ADDENDUM No. 1

RFP No.: 20-21/10, Oakland International Airport Post-Construction/Green Infrastructure Stormwater Treatment Assessment

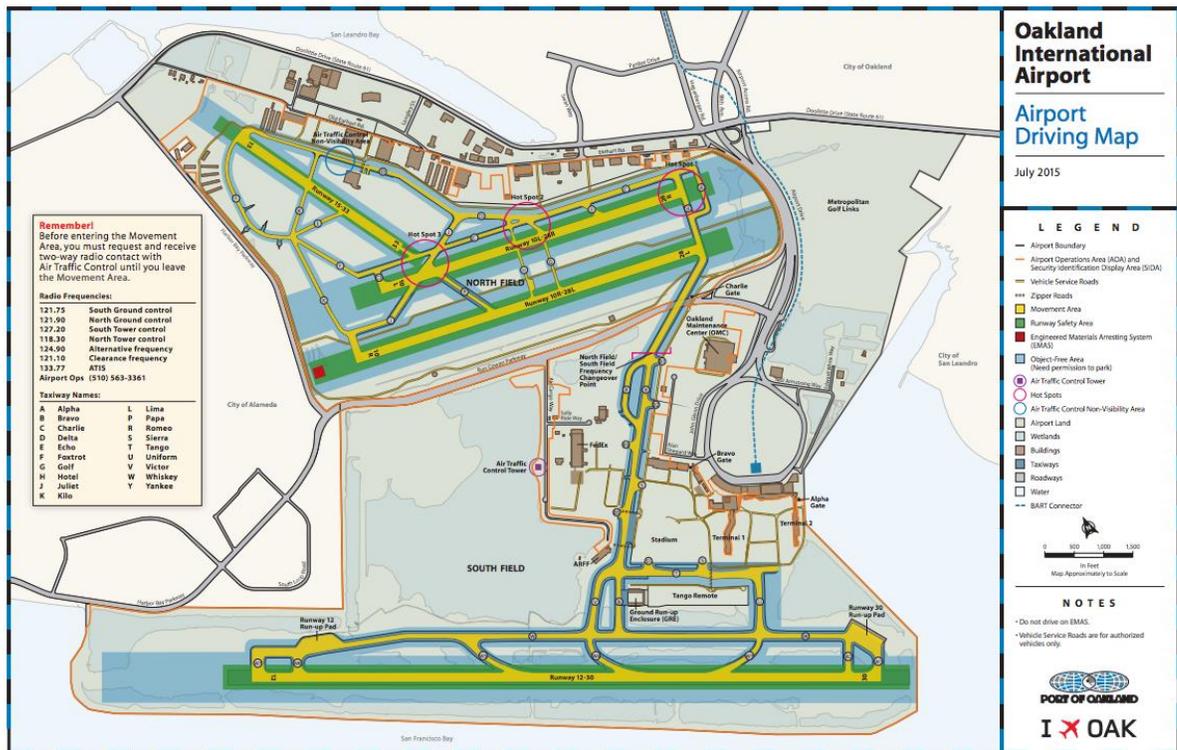
15. **Question:** What is the specific extent/boundary of the “airport campus” identified in the RFP? Can a map be provided?

Answer: The Airport campus is shaded in green, as indicated below:
